CITY OF OREGON CITY HISTORIC REVIEW BOARD AGENDA

Virtual Meeting
Tuesday, January 24, 2023 at 7:00 PM

Staff Report

GLUA-22-00039 and HR 22-00013: Historic Review for solar panel installation of street-facing roof planes on a designated structure in the McLoughlin Conservation district, the William T. Whitlock House at 1216 Jackson Street.

DRAWING BY: PremiumCAD	
PLOT DATE: November 6, 2022	
PROJECT NUMBER: 641584	
SHEET NAME: STRUCTURAL	
REVISION: 0	PAGE NUMBER: Page 58

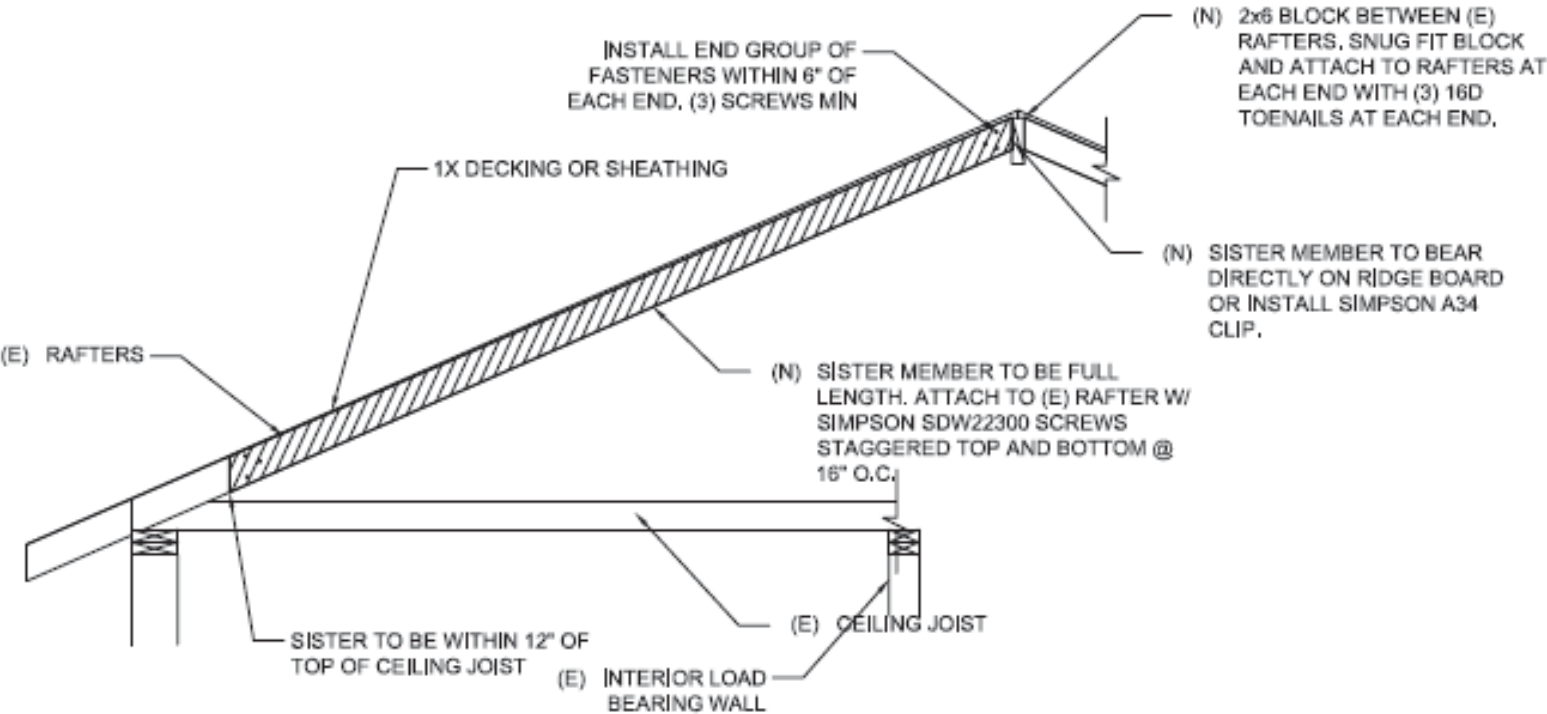
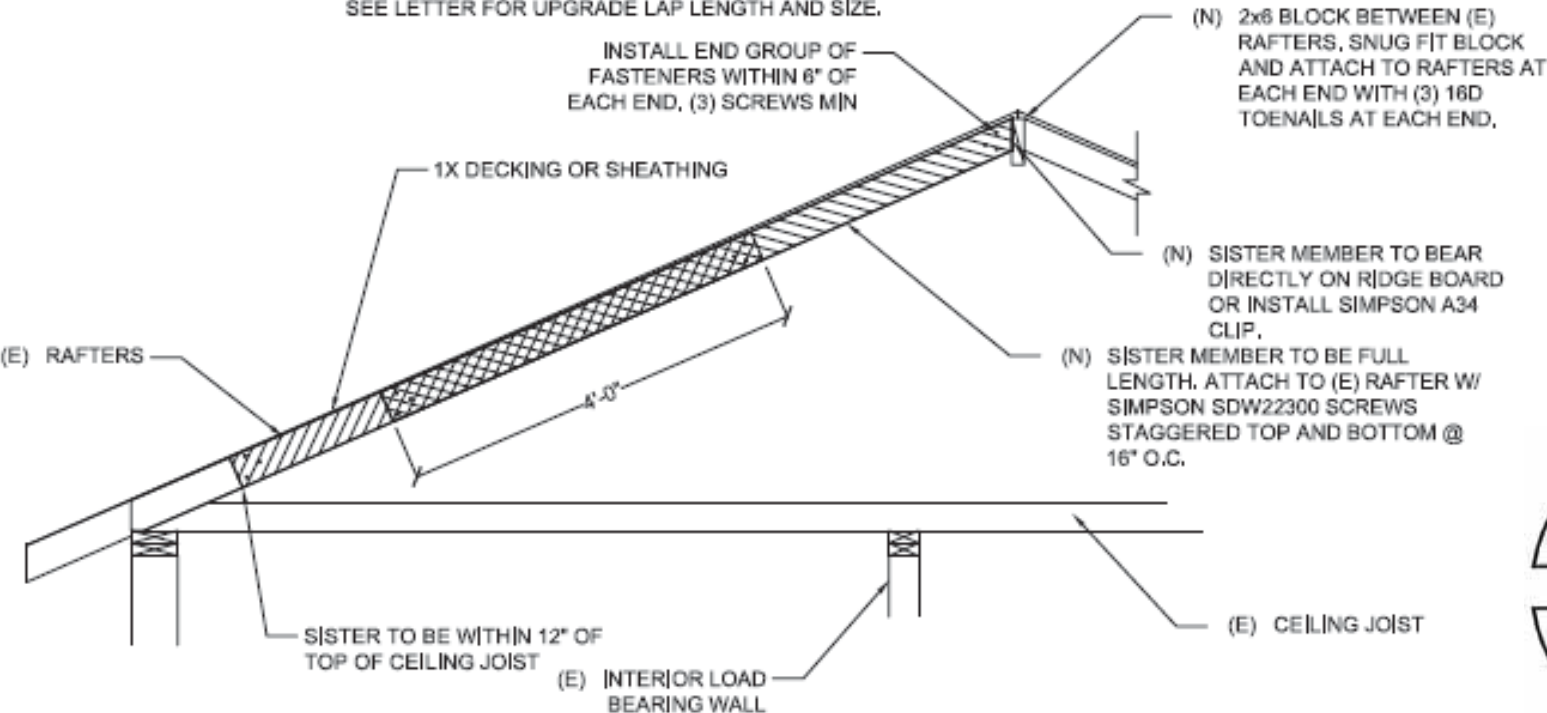
Sister upgrade is required for (MP1) on all rafters that directly support solar PV. Stitch new 2x4 DF#2 (min) to existing member. See detail for additional information.

OPTION 1 - FULL LENGTH SISTER
SEE LETTER FOR UPGRADE LAP LENGTH AND SIZE.

OPTION 2 - OVERLAPPED SISTER
SEE LETTER FOR UPGRADE LAP LENGTH AND SIZE.

REAR ELEVATION W/ PROPOSED RAMP
SCALE: 1/4"=1'-0"

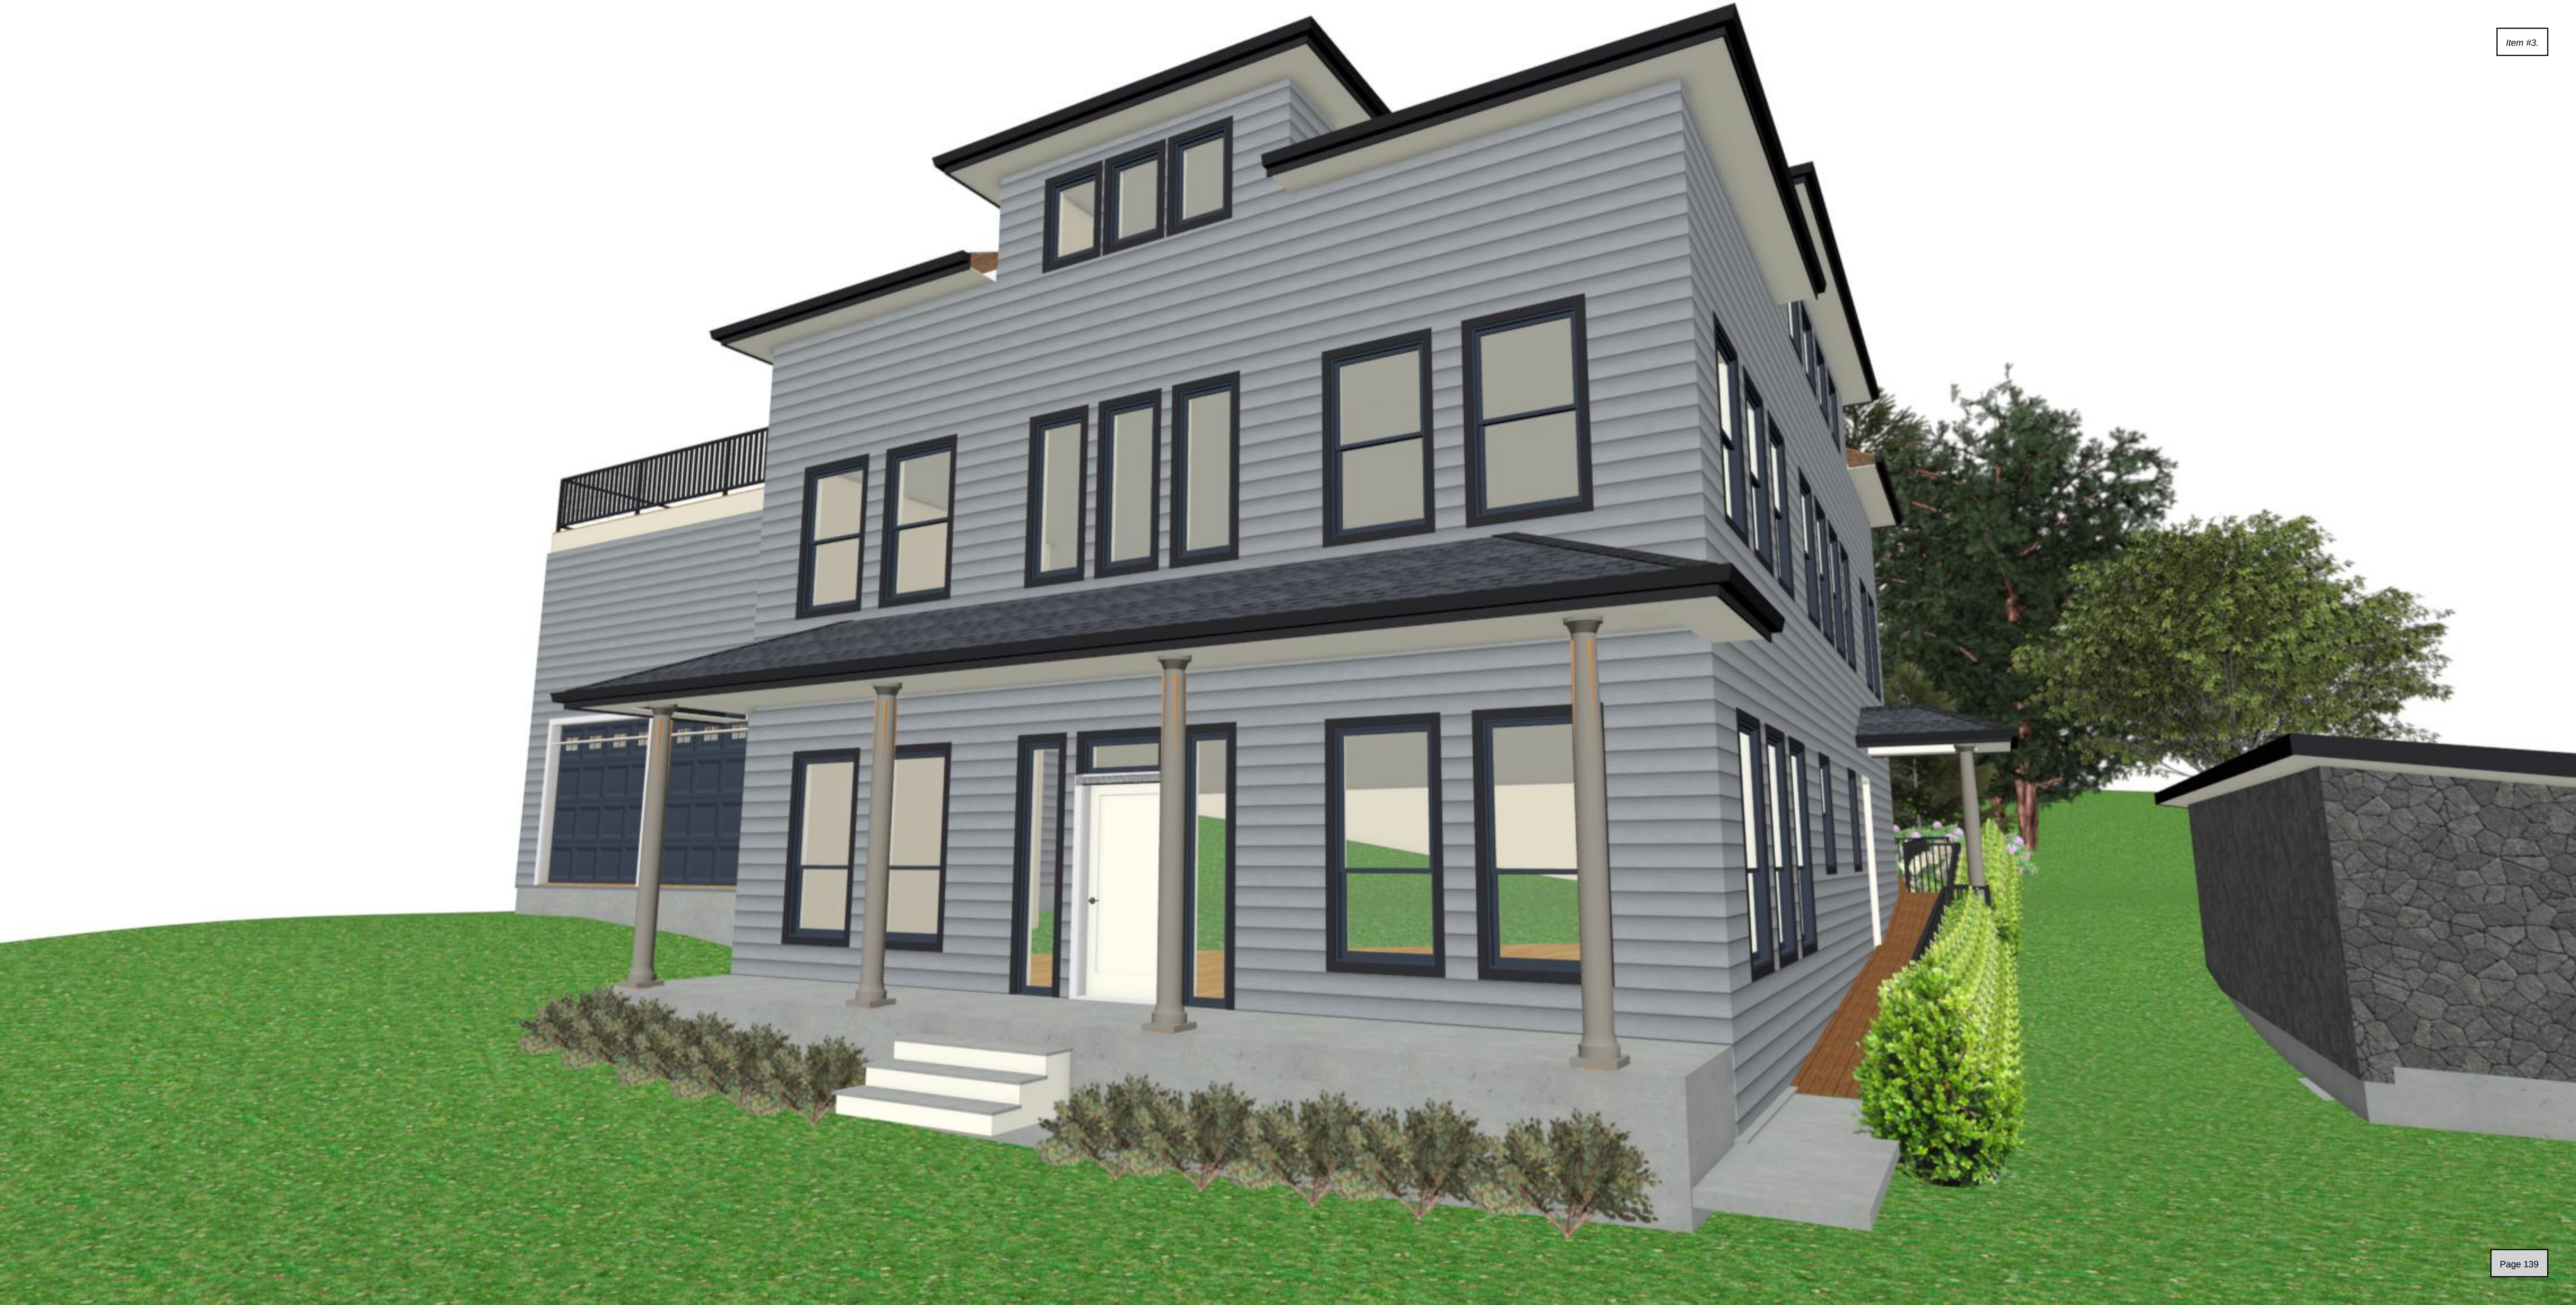
The applicant continues to assert that an elevator would be cost prohibitive but has yet to provide any supporting documentation of this. It is imperative the alternatives analysis requested repeatedly by Staff include the complex proposed ramp in its entirety (ramp, guardrails, screening walls, landscaping, etc.). All elements associated with the ramp need to be included in this estimate in order to provide a valid basis for comparison to the other requested alternatives. Since the building is nearly completed, it is reasonable to assume the applicant has actual bids for this work and can easily include them in the alternatives analysis.

The ramp needs to tie into the public sidewalk and landing at front steps. These two elements have been constructed (Figure 4 photo). Show the completed public sidewalk and front step landing with elevations as needed to demonstrate a compliant segment of ramp in front of the building (red area in sketch below). Because there is limited space to accomplish this, the public sidewalk/private ramp tie-in needs to be designed (calculated and drawn accurately) to avoid non-compliant work being demolished and replaced. Please add this to the next submittal.
